ERRATA:
Summary of solenoid field and location studies using the six way
probe and load cells

Glen Marshall
23 October 2001

There were some errors in the previous report of 10 October, and a potential additional systematic uncertainty has been recognized.

Figure 1: Original solenoid location, 48 A (corrected x and y).

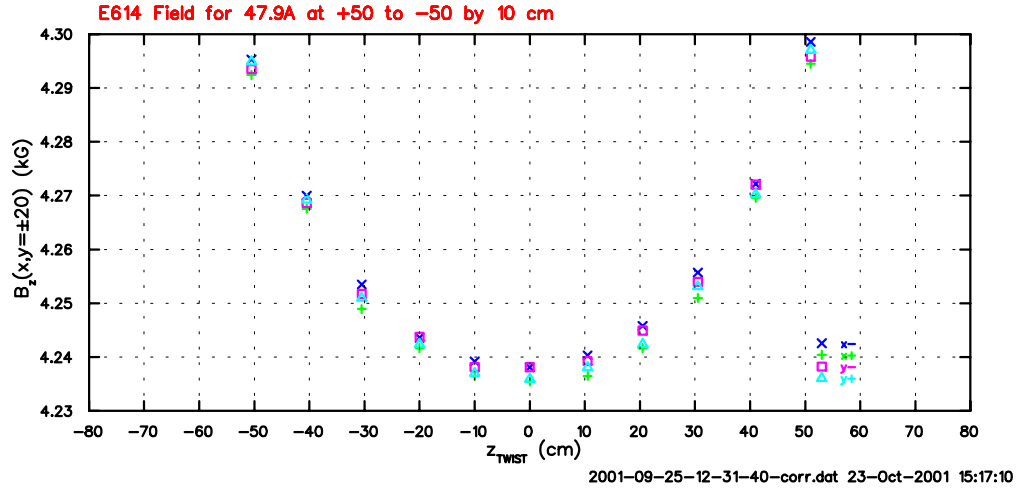
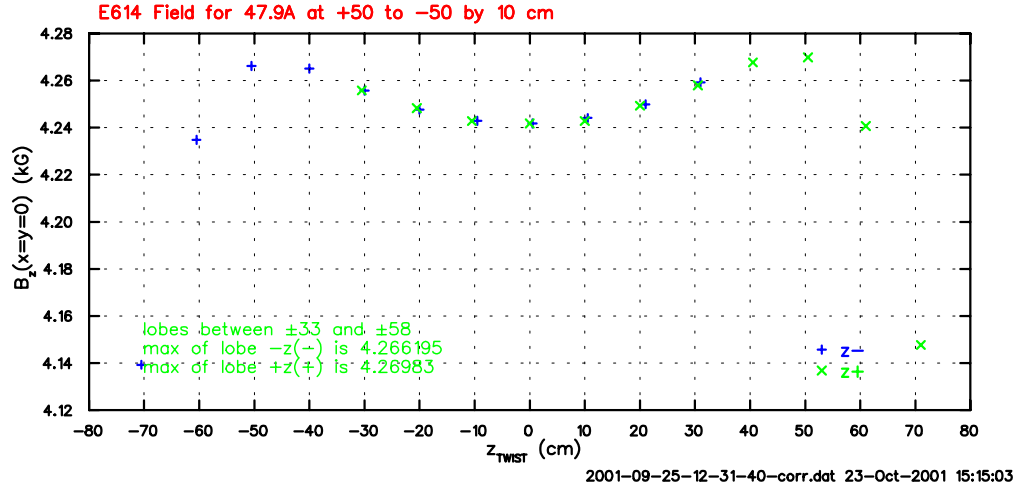
In the analysis of the fields measured by the six way probe, the values for the probes at $x = -20$ cm and $y = -20$ cm were inverted, due to a labelling error on the six way device. This means that the middle and especially the bottom graphs in Figs. 5-10 are incorrect. The bottom graphs were supposed to show the differences $B(x = +20) - B(x = -20)$ as Δx and $B(y = +20) - B(y = -20)$ as Δy .

Corrected versions of these figures are included here as Figs. 1-5.
